ADDENDUM NO. 1

Date:	January 4, 2010
To:	Pre-Qualified General Contractors
From:	Wayne Smith – Project Manager
Reference:	Richfield Armory Upgrade Utah National Guard – Richfield, Utah DFCM Project No. 09219470
Subject:	**Addendum No. 1**

ADDENDUM #1

PROJECT: Utah National Guard
Richfield Armory Upgrade
Project No. - 09219470
620 W 200 S
Richfield, UT 84701

1 M-201 **MECHANICAL FLOOR PLAN**

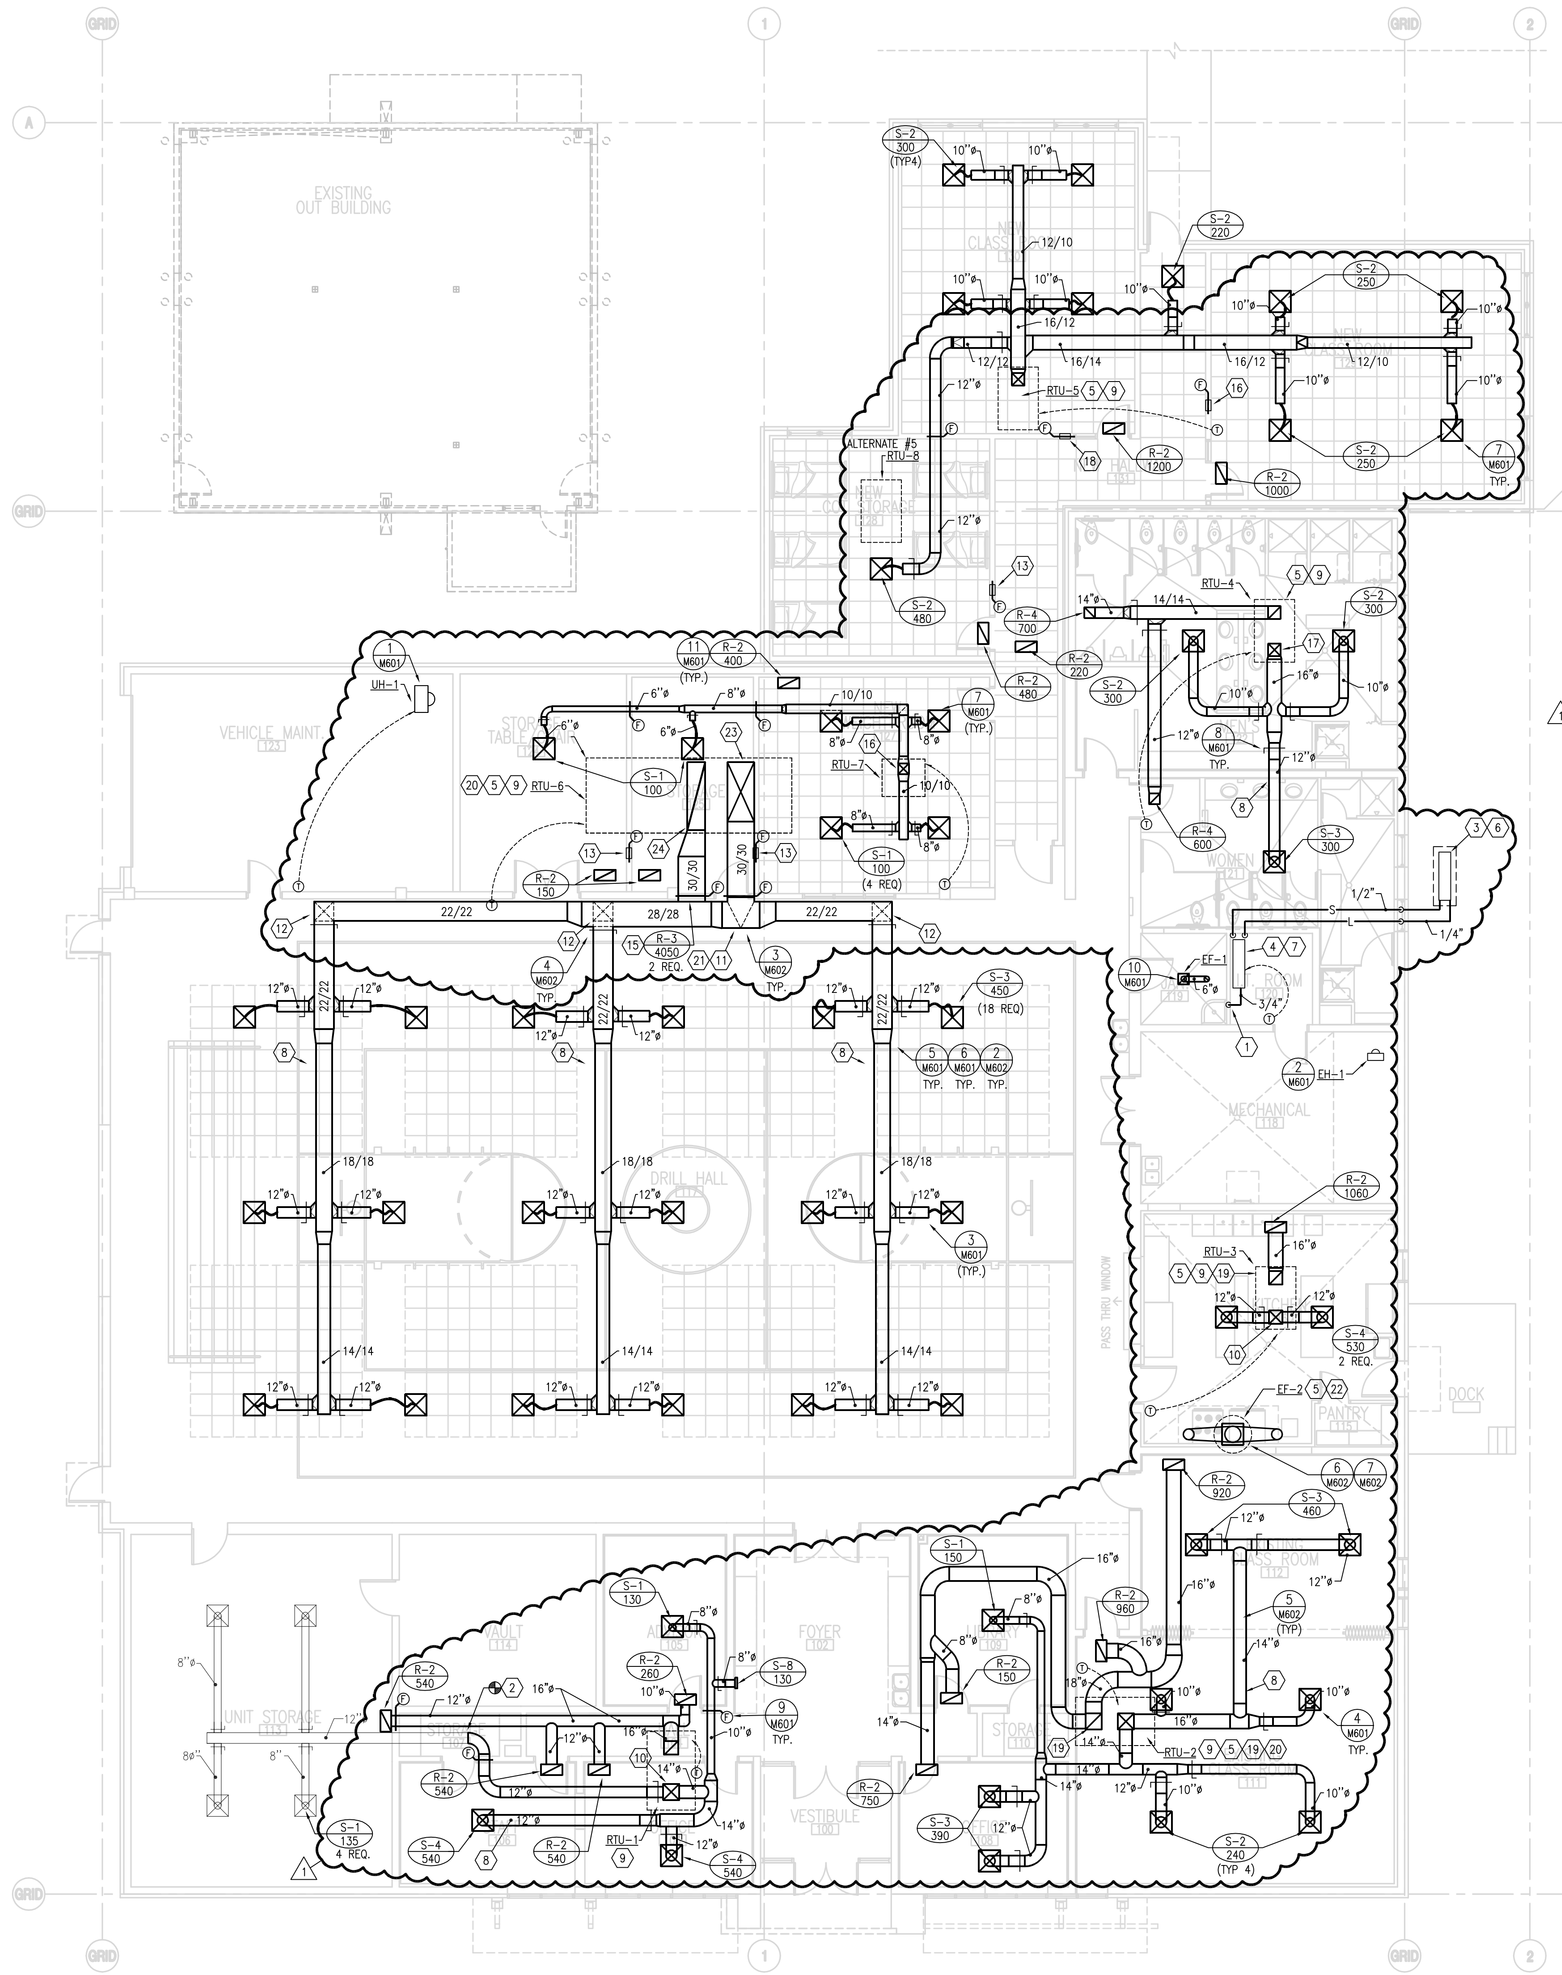
29. SHEET M-201 MECHANICAL FLOOR PLAN: (See attached drawing)
29.1. Sheet reissued as it modifies the ductwork shown on the drawings.
29.2. The room name label of New Cot Storage #128 should be replaced with New Classroom #128 as per architectural.

1 M-200 **MECHANICAL DEMO PLAN**

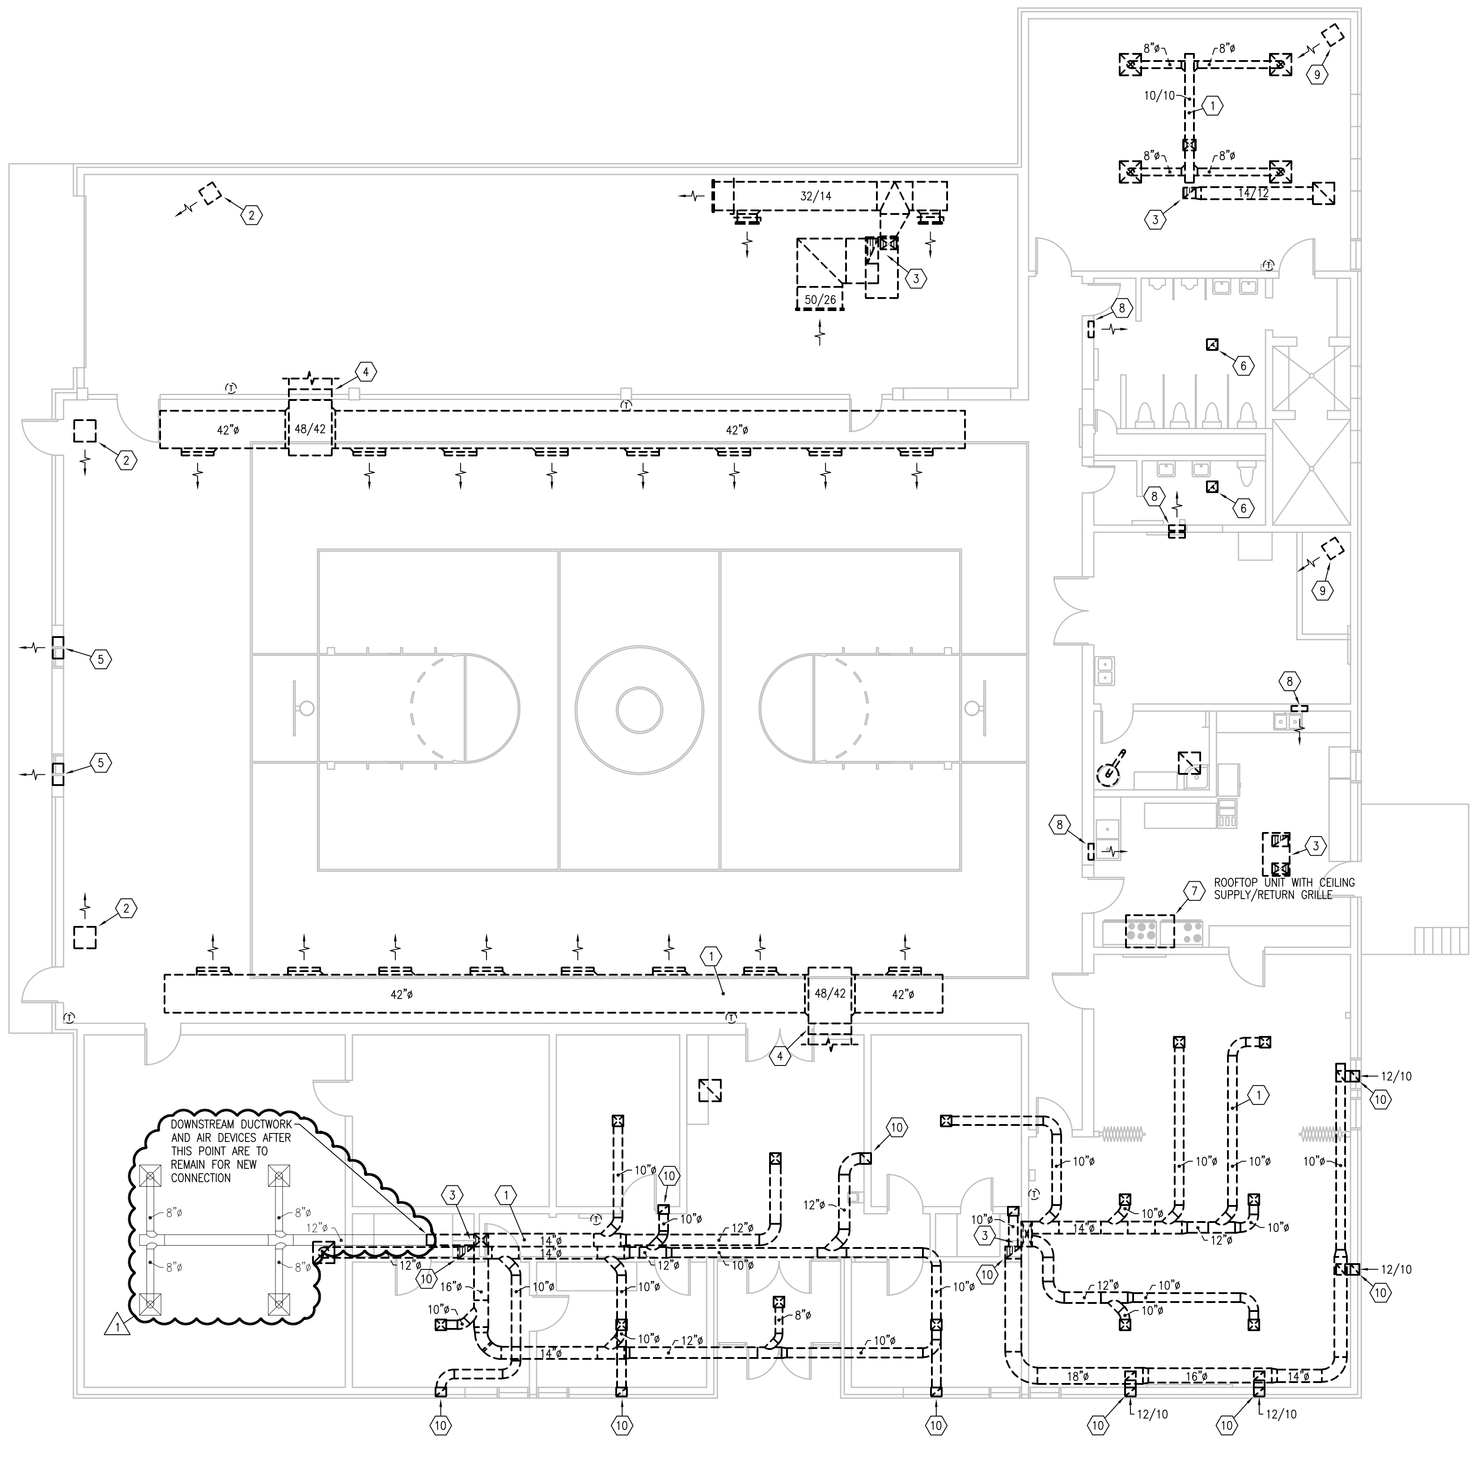
27.2. Door Frame Type F3: The sidelite glazing should be changed from 'D' to 'F'.
28. SHEET M-200 MECHANICAL DEMO PLAN: (See attached drawing)
28.1. Sheet reissued as it deletes the demolition requirement of the duct work in Storage Room #113.

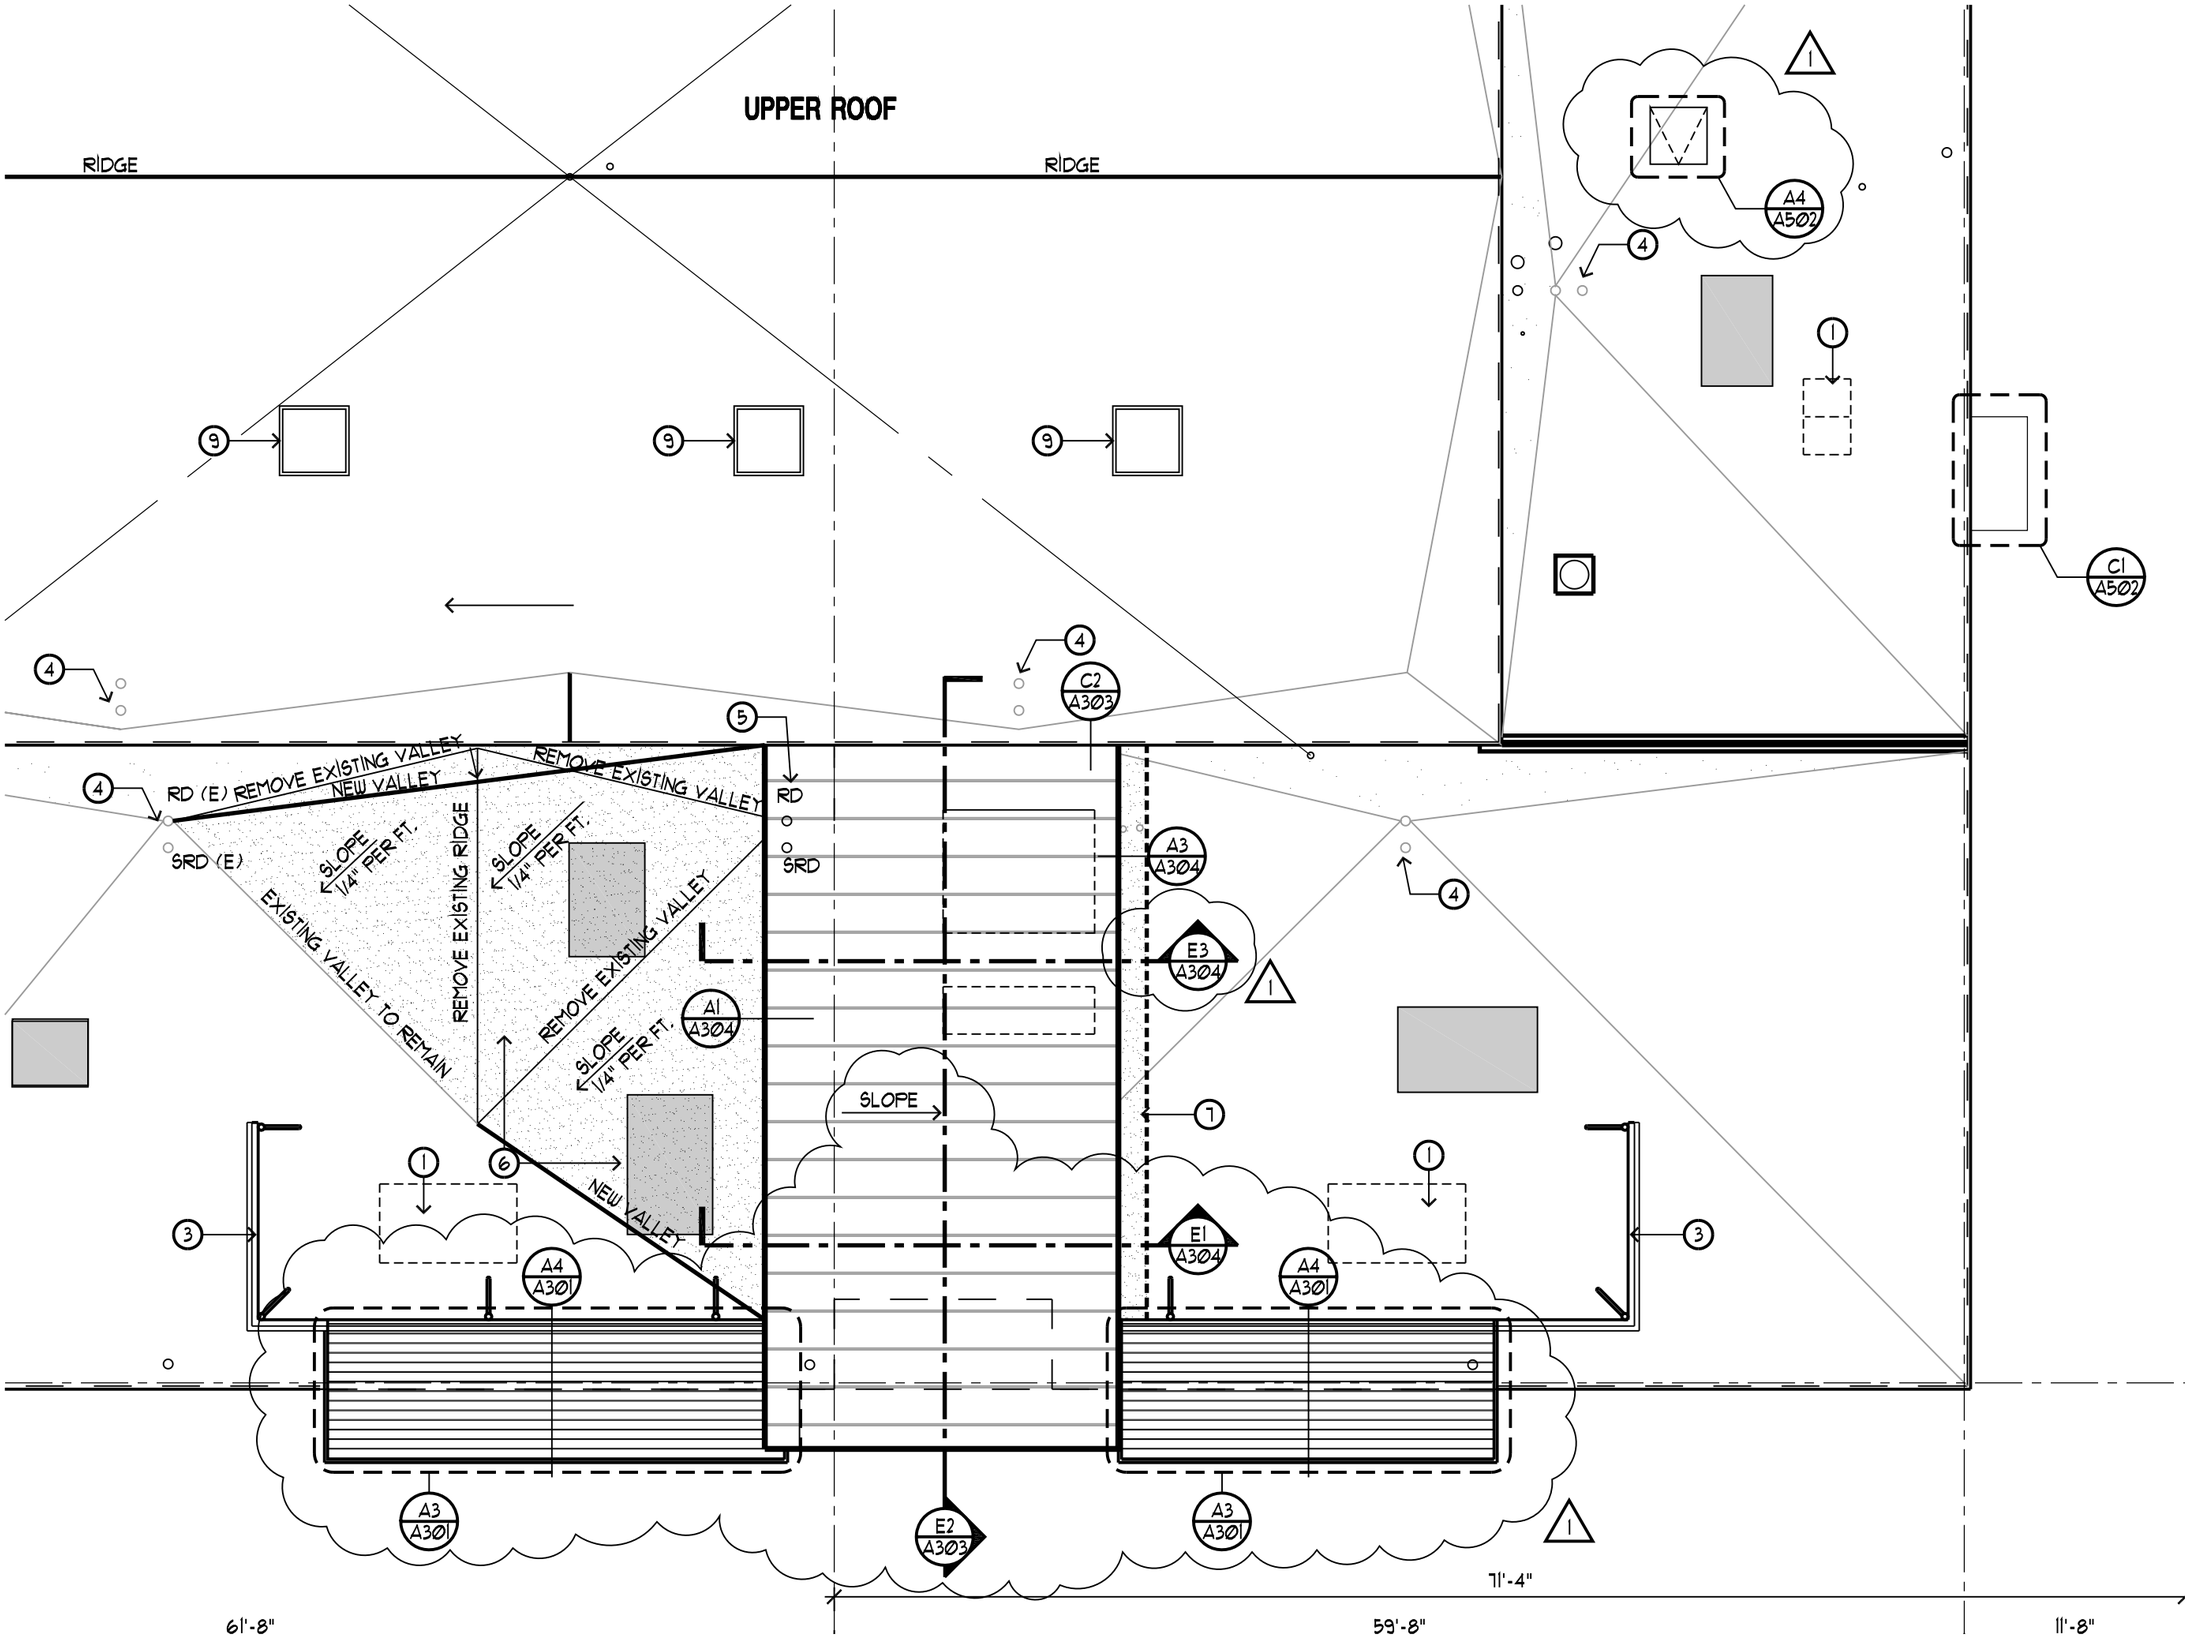
20.1. See attached drawing which modified the trellis, the slope of the new raised roofing area over the lobby, and the roof hatch location.

SITE PLAN

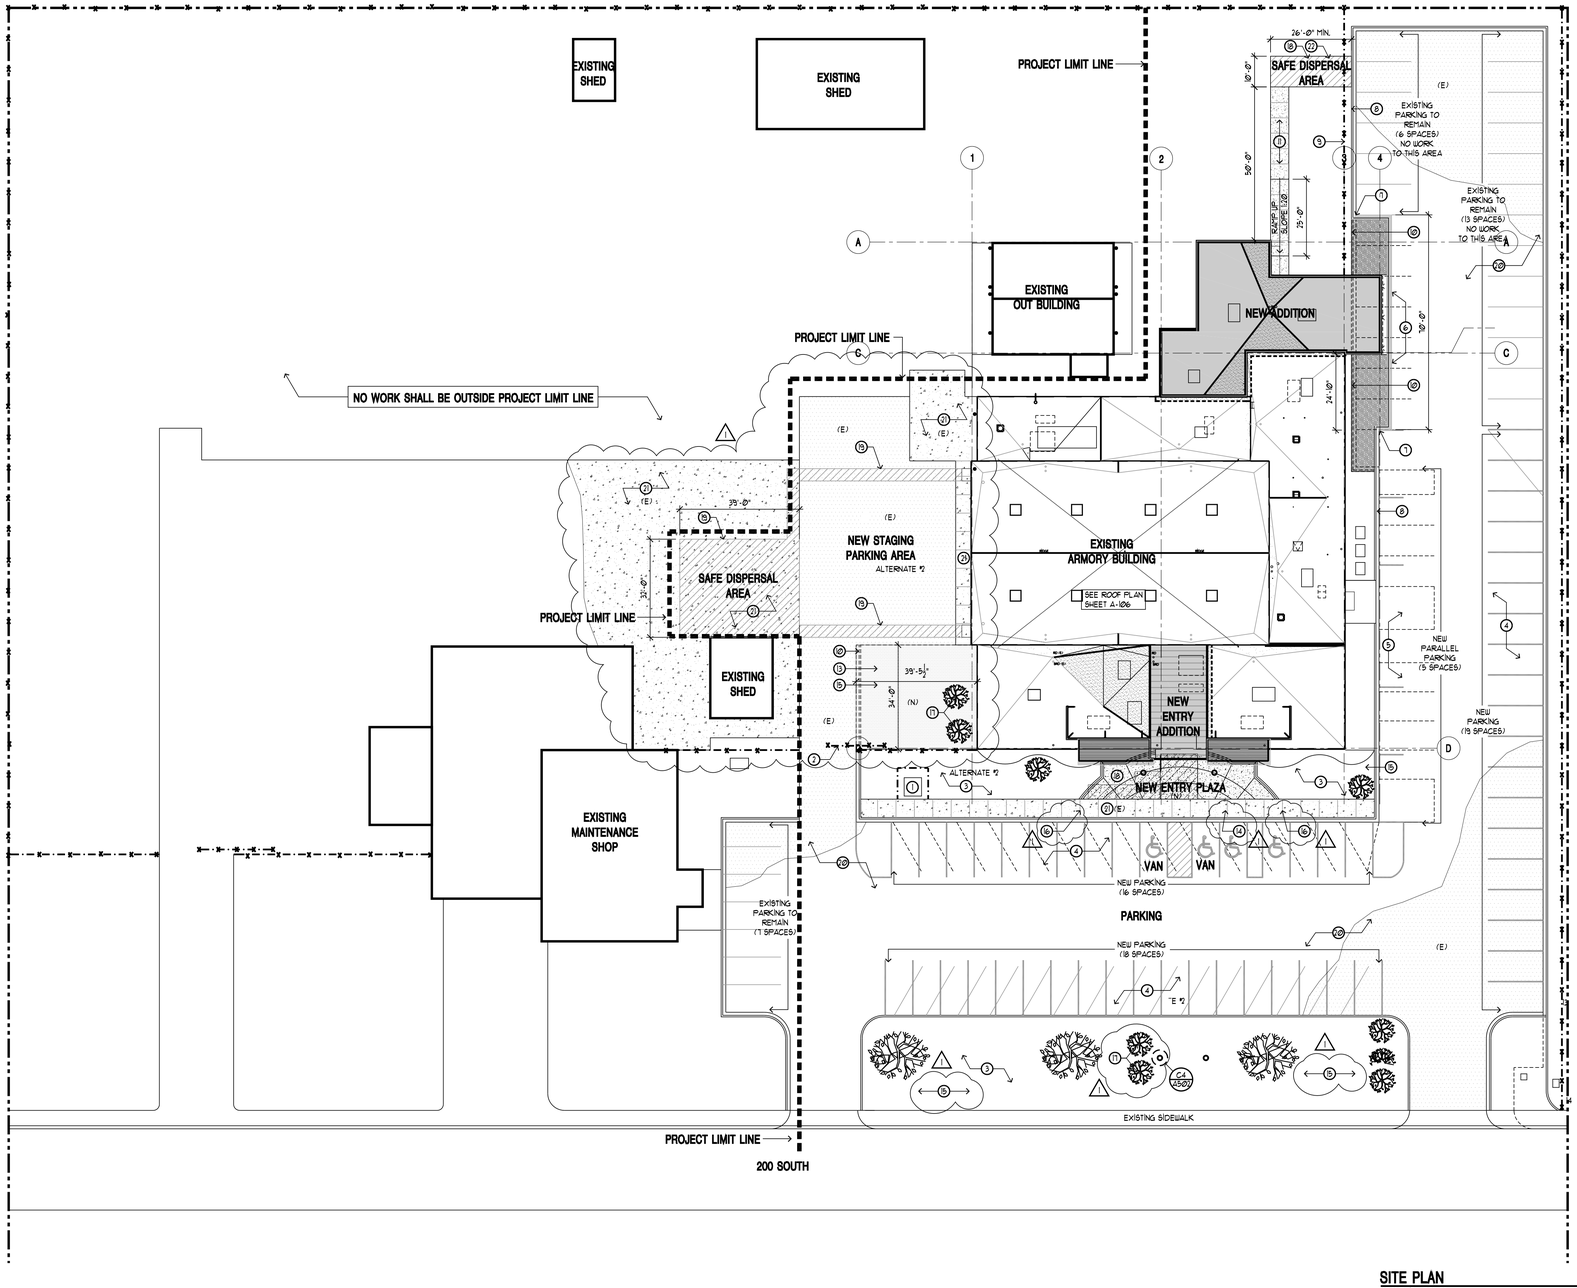
18.2. Keynotes 12-20 added.

18.3. Asphalt Paving extent clarified and paving notes added.
